This Addendum forms a part of the Contract Documents and modifies the original Bidding Documents dated July 2, 2026, as noted below. Acknowledge receipt of the Addendum in the space provided on the Bid Form. Failure to do so may subject the Bidder to disqualification.

Project Name	Wellness Center Re-Use Renovation BGS Project #3843			
Project Number	10017003			
Date	7/28/2026			
Prepared By	Dan Rowland			
Number	Pre-Bid Request For Information	Discipline	A/E Response	Response date
1	Perimeter drain dumps where? No civil drawings	Arch	Tie into existing, if existing drains are not encountered, new perimeter drains are not required.	7/27/2026
2	Through bolts for canopy how many are needed at lower portion of canopy?	Arch	See Addendum #01 - Sheet AE101, Detail A15 is updated to reference (6) ½” thru-bolts EQ Space between canopy.	7/27/2026
3	Entrance slabs tie to sidewalks how? No detail showing this	Arch	A1/AE101 shows isolation joint.	7/27/2026
4	H1/AE101 notes 4” slabs but details D8 notes 5” and A1 notes 6” thick CIP and then shows dimensions of 5”.	Arch	Frost-protected slab shall be 5” per D8. See Addendum #01 - Sheet AE101, Detail A1 is updated to reference 4" concrete sidewalk

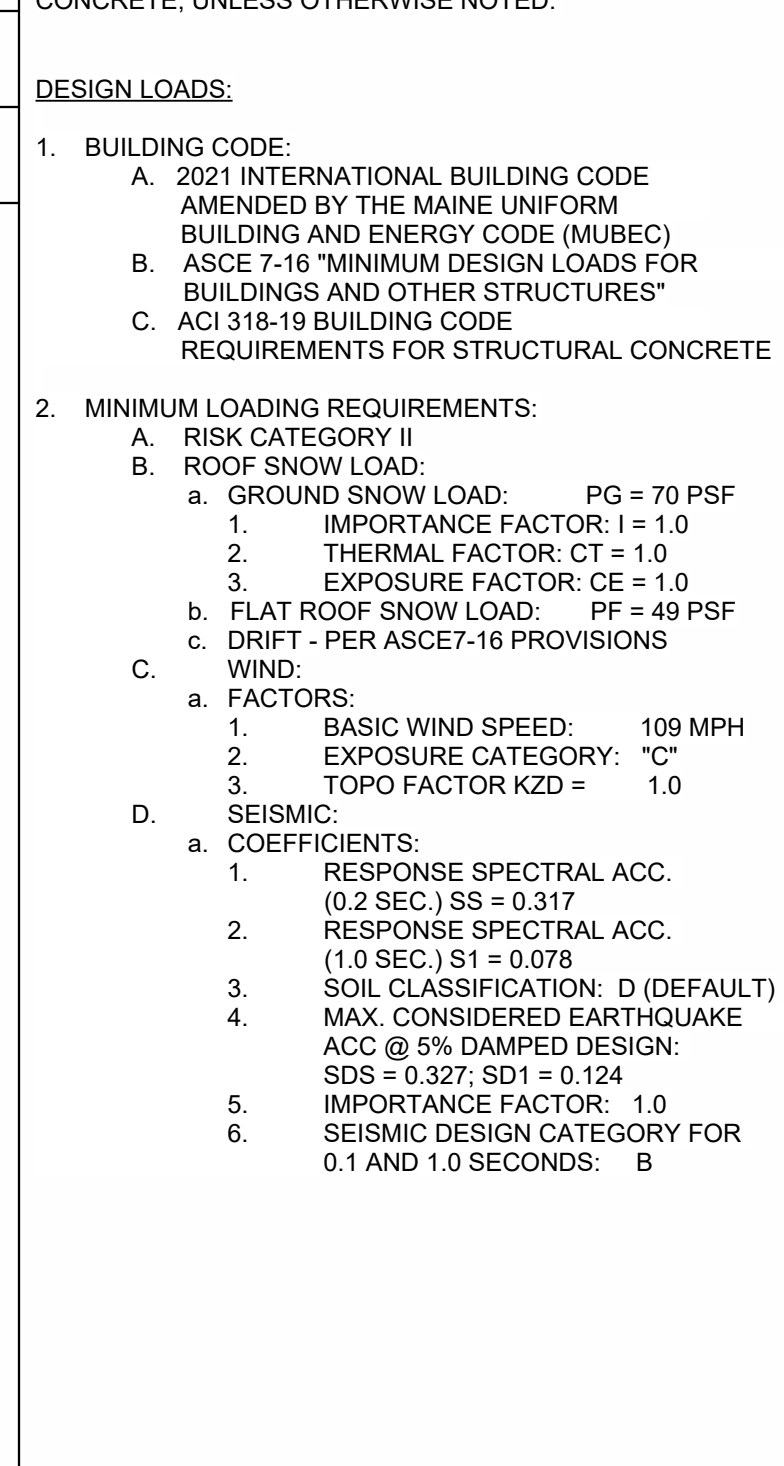
3. Sheet AE101, First Floor Plan & Details, DELETE and REPLACE with attached Sheet
 - a. Clarified Entry Stair Landing Dimension.
 - b. Added sidewalk control joints.
 - c. Clarified sidewalk thickness and mix psi.
 - d. Clarified existing wall insulation R-value
 - e. Clarified canopy connection
4. Sheet AE501, Removal & Construction Details, DELETE and REPLACE with attached Sheet.
 - a. Added North sidewalk plan.
 - b. Clarified stair railing note.
 - c. Added abrasive nosing.

15	A5/AE101 notes 2” R-20 rigid but 2” rigid is R-10	Arch	See Addendum #01 - Sheet AE101, Detail A5 is updated to reference R-10	7/27/2026
16	What is the thickness/height of the canopy roof structure?	Arch	Coordinate with canopy manufacturer.	7/27/2026
17	Painted downspouts? What size and just prefinished?	Arch	Coordinate size with Canopy manufacturer. Prefinished	7/27/2026
18	Any hazardous in the project?	Arch	None is anticipated	7/27/2026
19	The window brick infill is it to be toothed back in? 8” cmu toothed in? Is the cmu to be painted or is there a wall covering on the inside?	Arch	Yes, tooth brick and block in existing, paint interior cmu to match existing.	7/27/2026
20	Any control joints in concrete landing or sidewalks?	Arch	See Addendum #01 - Sheet AE101, Plan H1 and Sheet AE501, Detail G12 are updated to reference control joints at 10' oc for sidewalks. No control joints in frost-proof landings	7/27/2026

21	Sidewalk going to parking lot is just a straight path? Also is it 10'-0” to match other one?	Arch	See Addendum #01 - Sheet AE101, Plan H1 and Sheet AE501, Detail G12 are updated to reference layout of sidewalk.	7/27/2026
22				
23				
24				
25
